# Submissions Report

## Parramatta Over and Adjacent Station Development

November 2024

Submissions Report

Figure 3-2 Horwood Place layout, as exhibited (left) and as amended (right) with Building A podium articulation zone removed

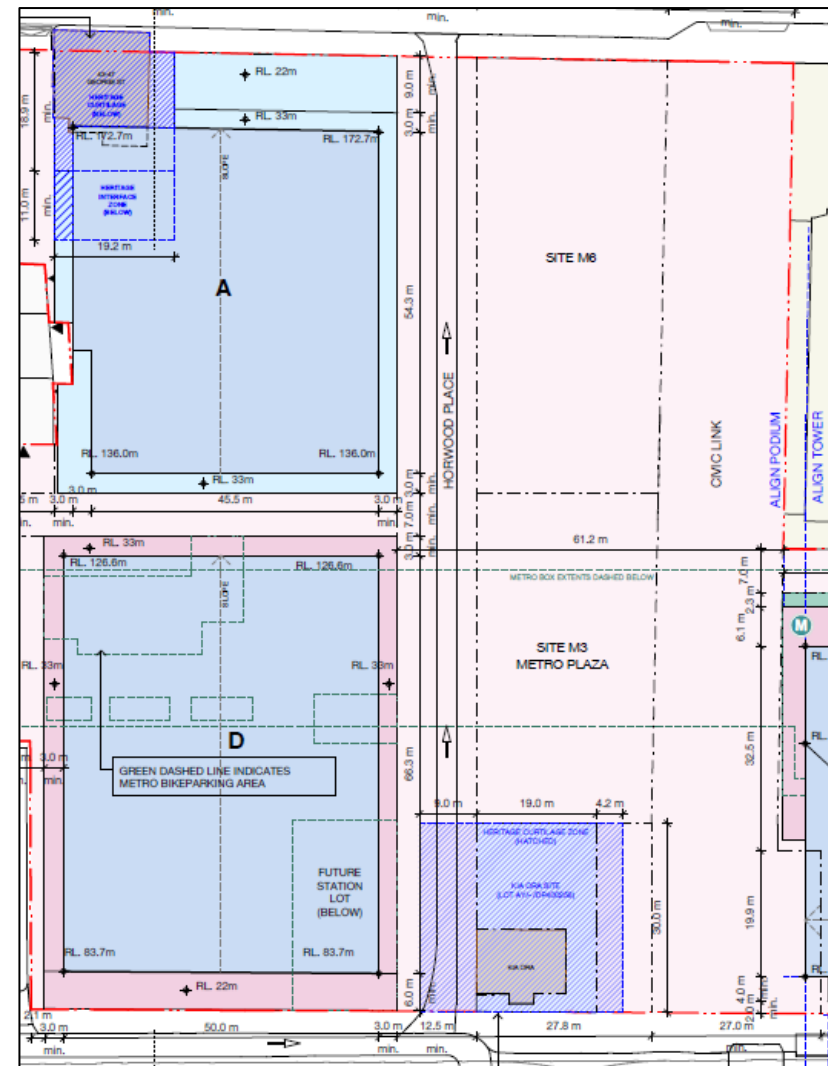
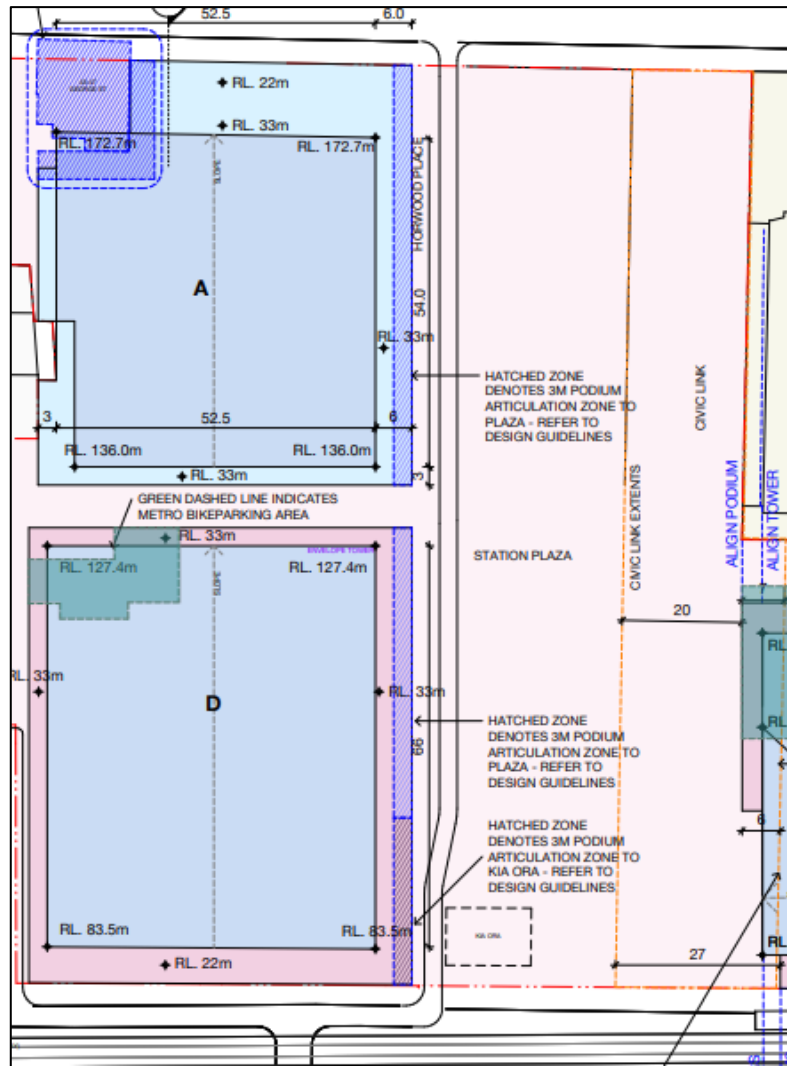
The built form along the western side of Horwood Place has been reduced, which addresses comments raised by City of Parramatta Council provides a higher level of consistency with the indicative built form layout as expressed in Section 6.5.2, Figure 6.5.2.4 (Civic Link Streets and Public Space) of the City of Parramatta Development Control Plan 2011 (PDCP 2011).

This has been achieved by removing the three metre podium articulation zone along the eastern elevation of Building A (Figure 3-2) and the eastern elevation of Buildings A and D towers have been reduced by approximately 7m (thereby reducing the floor plates). The realignment of Horwood Place also enables the removal of the three metre podium articulation zone along the western elevation of Building D, although this falls within the ongoing design development of the CSSI scope of work.

**Figure 3-3 Building B 3D SW View, as exhibited (left) and as amended (right), showing additional height to the south-western corner (red highlight)**

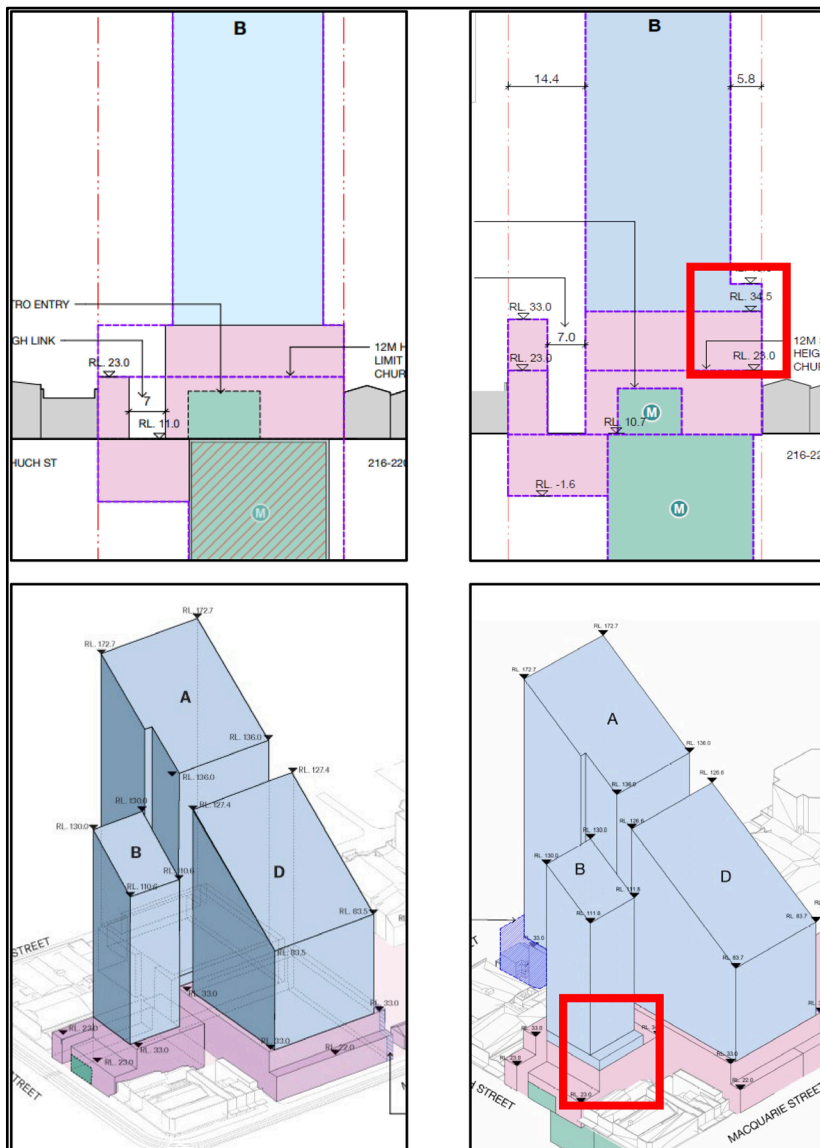
It is noted that this additional height is located within the OSD envelope as it accommodates OSD components, rather than the Stage 3 CSSI envelope below (Figure 3-3). The tower shoulder in the Indicative Reference Scheme incorporates plant/additional structural transfers for the OSD and is not intended to comprise of habitable floorspace. However, further design refinement will occur under a future Detailed SSDA, which may or may not seek to utilise the shoulder depending on final servicing requirements.

Furthermore, the Parramatta Over and Adjacent Station Development Design Guidelines (Appendix F) have been amended to include design guidance as to where stepping is required for the tower shoulder, a sensitive architectural response is required.

**Figure 3-4 Building B indicative reference scheme section, as exhibited (left) and as amended (right), showing additional retail and the introduction of commercial floorspace (red highlight)**

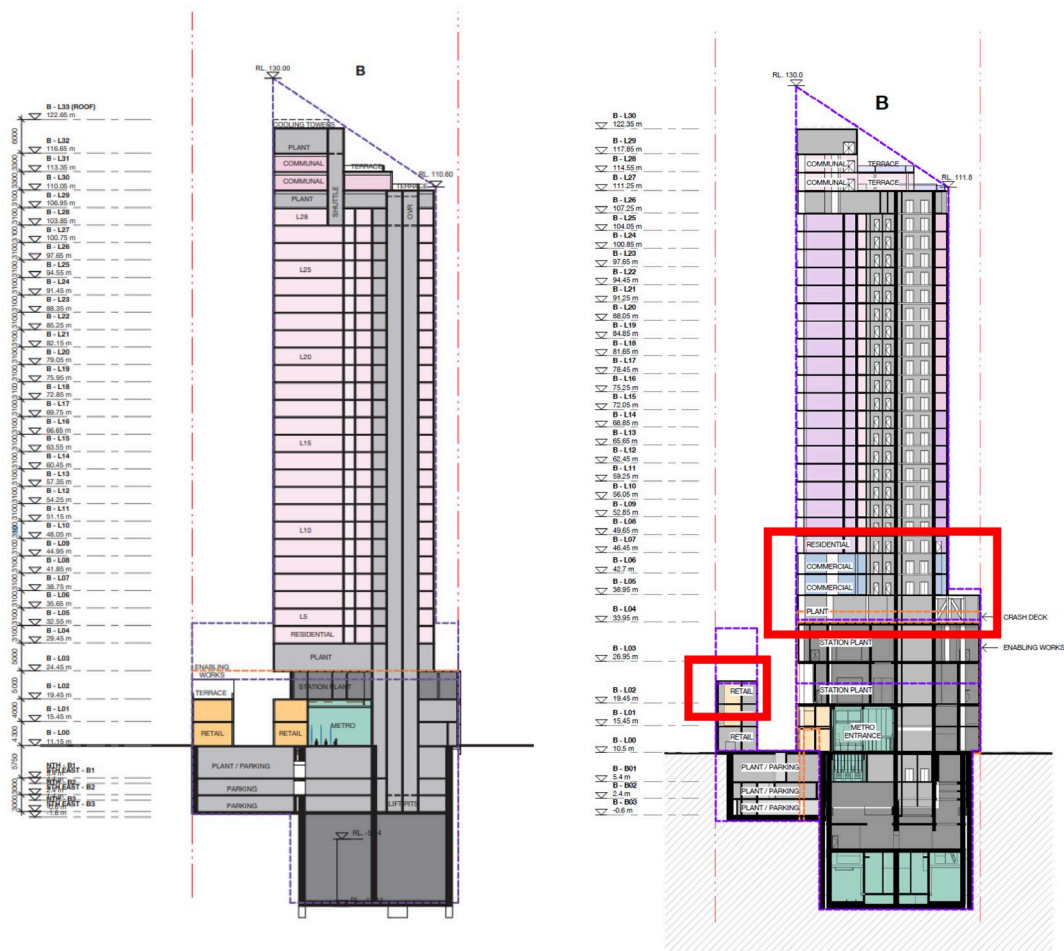
In response to comments from City of Parramatta Council, the quantum of commercial floorspace in Building B has been increased from 1,100m<sup>2</sup> (retail) to 2,616m<sup>2</sup> (including 1,494m<sup>2</sup> commercial and 1,122m<sup>2</sup> retail) in compliance with Clause 7.24 of the PLEP 2011 which requires a minimum of 1:1 commercial FSR to be provided within the building.

Amendments have been made to the Indicative Reference Scheme to show how this additional floorspace may be accommodated. This includes the following design changes (Figure 3-4):

- expanding the quantum of retail floorspace on ground level
- introducing retail floorspace to Level 2 fronting 240 Church Street, increasing the height at this location from RL 23 to RL 33 (**note:** the increase to the height of the podium from RL 23 to RL 33 will be considered in the Stage 3 CSSI as part of further design development)
- introducing commercial office floorspace to Levels 5 and 6

**Figure 3-5 Building B tower envelope, as exhibited (left) and as amended (right), with southern setback increased from 4.5m to 6m**

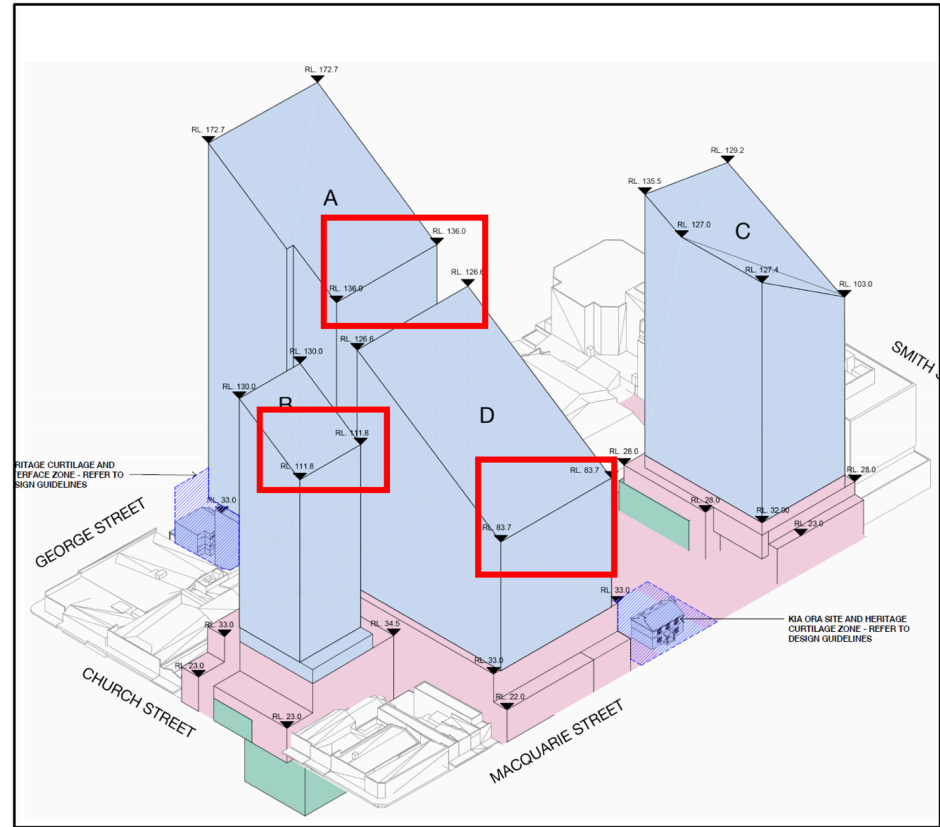
The southern setback of the Building B tower envelope has been increased from 4.5 metres to 6 metres in response to DPPI advice. The Building B tower envelope as exhibited adopted a 4.5 metre setback to the southern boundary on the basis that the southern building facade contains no windows.

In response to advice from DPPI, the southern setback has been increased from 4.5 metres to 6 metres for full compliance with the Apartment Design Guide (ADG), refer to Figure 3-5. Six metres is a complying side boundary setback dimension for a building which is nine and above storeys in height, provided that visual privacy is maintained between Building B and future development to the south.

**Figure 3-6 Building envelopes, as exhibited (left) and as amended (right), with adjustments to Building B and D highlighted in red**

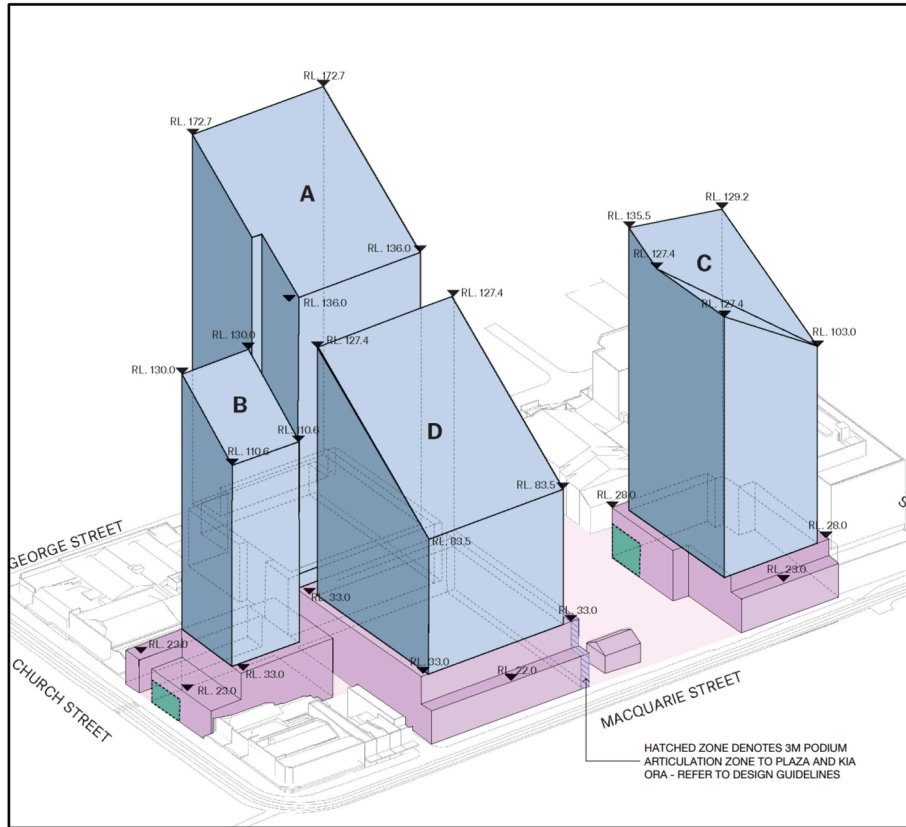
Minimal adjustments are proposed to the maximum building heights of the Buildings B and D envelopes following further detailed design and coordination (Figure 3-6). No increase is proposed to the overall maximum heights of any envelope. Specifically, there is an:

- Increase in height of the southern edge of the Building D tower envelope from RL 83.5 to RL 83.7.
- Decrease in height of the northern edge of the Building D tower envelope from RL 127.4 to RL 126.6.
- Increase in height of the southern edge of the Building B tower envelope from RL 110.6 to RL 111.8.

**Figure 3-7 Potential additional car parking under Horwood Place**

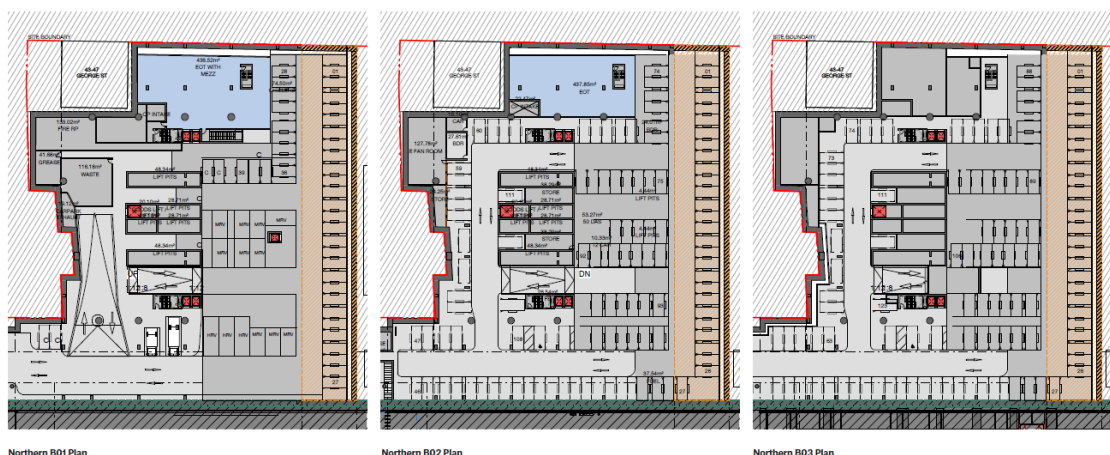
Notwithstanding the refinement to the Indicative Reference Scheme, the proposal seeks a maximum of 451 car parking spaces given this can be achieved within the parameters of the Stage 3 CSSI Approval basement shell. Figure 3-7 below demonstrates that an additional 145 car parking spaces can be achieved within the approved basement shell.

**Figure 3-8 Potential additional car parking within future station lot in southern basement**

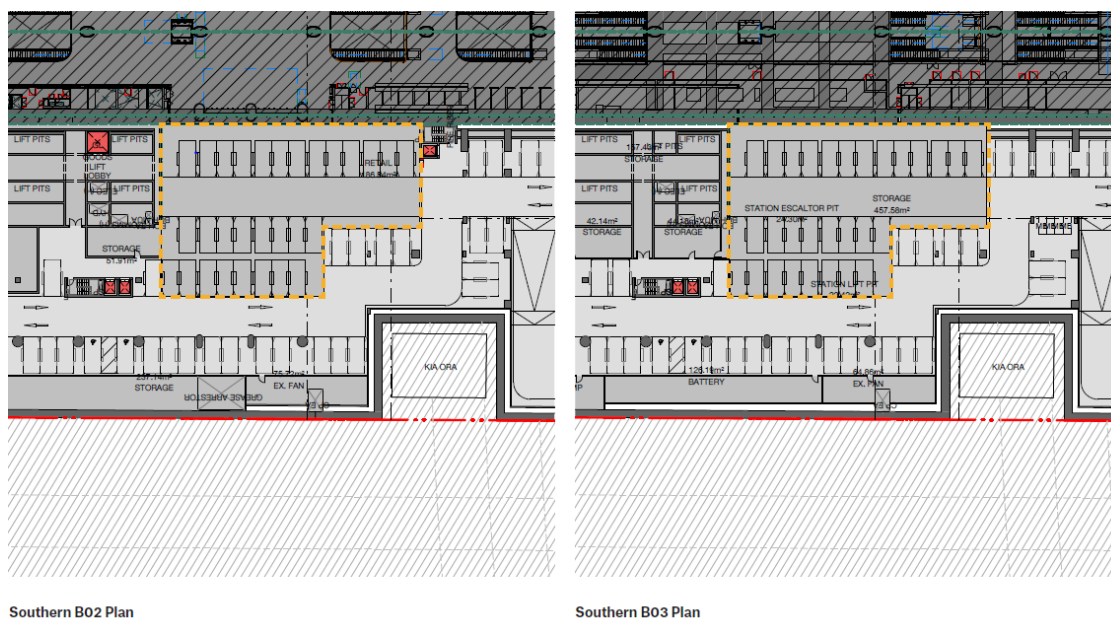
Additionally, the potential removal of the future station lot from the southern basement (which is within the approved basement shell) would result in an additional 58 car parking spaces being achieved as illustrated in Figure 3-8 below. Refer to the Appendix R - Demarcation Drawings for further detail on the additional car parking numbers and location of these areas on the basement plans.
